## PIC12F629/675 Rev. A Silicon/Data Sheet Errata

The PIC12F629/675 parts you have received conform functionally to the Device Data Sheet (DS41190C), except for the anomalies described below.

### Clarifications/Corrections to the Data Sheet:

## REGISTER 3-2: TRISIO – GPIO TRI-STATE REGISTER (ADDRESS: 85h)

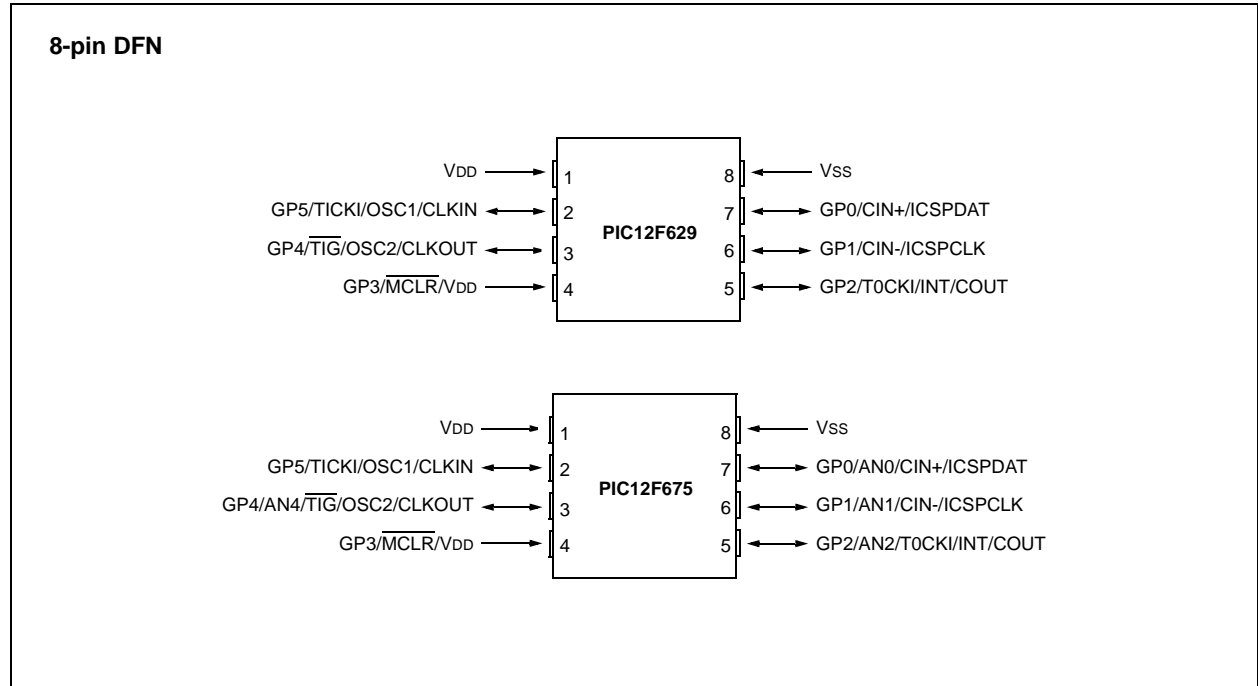
Register 3-2, "TRISIO – GPIO Tri-state Register (Address: 85h)", is incorrect. Bits 5-4 and 2-0 should read "R/W-1", as shown below:

U-0	U-0	R/W-1	R/W-1	R-1	R/W-1	R/W-1	R/W-1	
—	—	TRISIO5	TRISIO4	TRISIO3 <sup>(1)</sup>	TRISIO2	TRISIO1	TRISIO0	
bit 7								bit 0

## 8-Lead Plastic Dual Flat No Lead Package (MD) 4x4x0.9 mm Body (DFN) – Saw Singulated

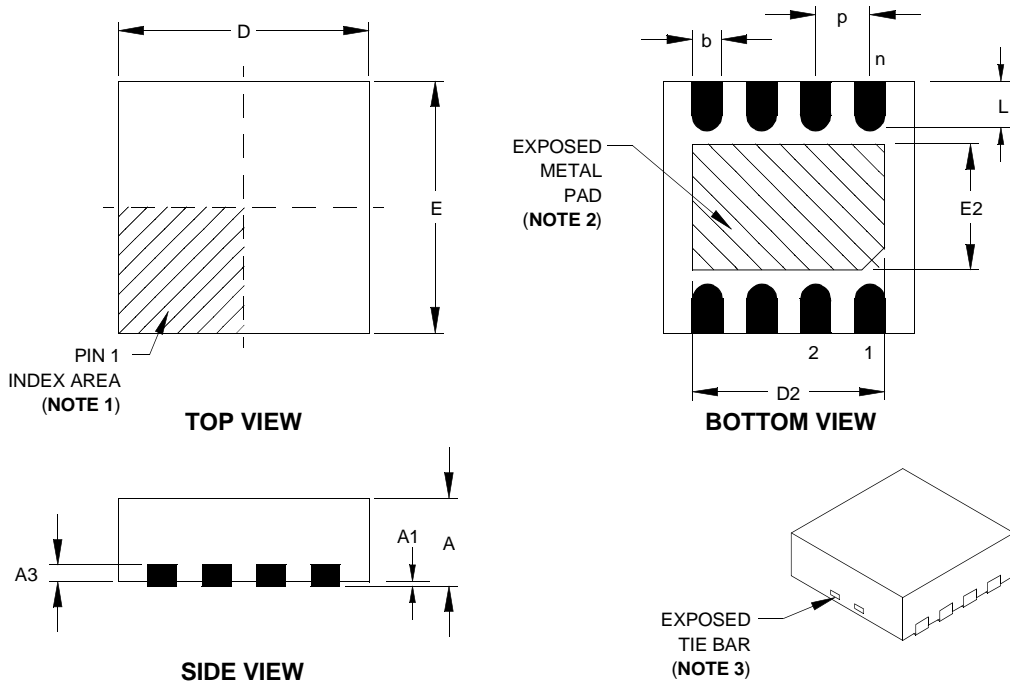
The new 8-pin 4x4 DFN pinout diagram will be added to the Pin Diagrams figure on page 2 and the Packaging Information chapter as shown below:
